# Access Compliance Report

## Public Rights-of-Way

### (Curb Ramps)

Intersection ID: 15017	Main Street: BALTIMORE_AV	Cross Street: GRIFFITH_ST	Location: S
ADA ID: CD38865616CA	Ramp Type: PerpDiag	Initial Pass/Fail: Fail	Overall Compliance: No
Severity Score: 10			
Codes/Mitigation Info/Possible Solution		Field Measurements/Component Compliance

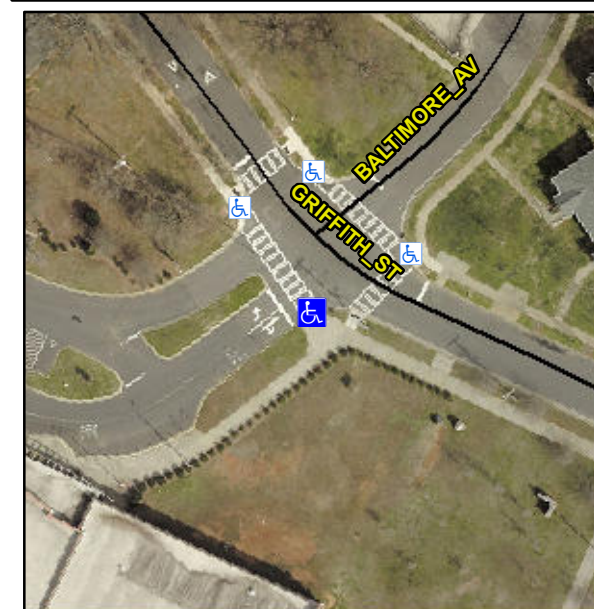
**Not Found, R304.5.1, R304.5.3**

Compliance	Description	Data	Compliance	Description	Data
N/A	Ramp Length (in)	180.0	Yes	Ramp Slope (%)	6.2
No	Ramp Width (in)	47.0	No	Ramp XSlope (%)	2.1
N/A	Flare Type LT	N/A	N/A	Flare Type RT	N/A
N/A	Flare Slope LT (%)	N/A	N/A	Flare Slope RT (%)	N/A
N/A	Flare Traversable LT?	N/A	N/A	Flare Traversable RT?	N/A
N/A	Landing Length (in)	N/A	N/A	DWS Provided?	N/A
N/A	Landing Width (in)	N/A	N/A	DWS Contrast?	N/A
N/A	Landing Slope (%)	N/A	N/A	DWS Length (in)	N/A
N/A	Landing X Slope (%)	N/A	N/A	DWS Full Width?	N/A
N/A	Landing Curb? (Y/N)	N/A	N/A	DWS Offset (in)	N/A
N/A	Shared Landing?	N/A			
N/A	Gutter Ponding?	N/A	N/A	Gutter Slope (%)	N/A
N/A	Gutter Lip Ht (in)	N/A	N/A	Gutter X Slope (%)	N/A
N/A	Painted X Walk1?	No	N/A	Painted X Walk2?	Yes
	X Walk 1 Direction	To NE		X Walk 2 Direction	To NW
N/A	X Walk 1 Width (in)	N/A	N/A	X Walk 2 Width (in)	116.0
	X Walk 1 Slope (%)	1.4		X Walk 2 Slope (%)	0.7
	X Walk 1 X Slope (%)	3.5		X Walk 2 X Slope (%)	0.9

**Remove & Replace Curb Ramp With Two New Directional Ramps or Equivalent.**
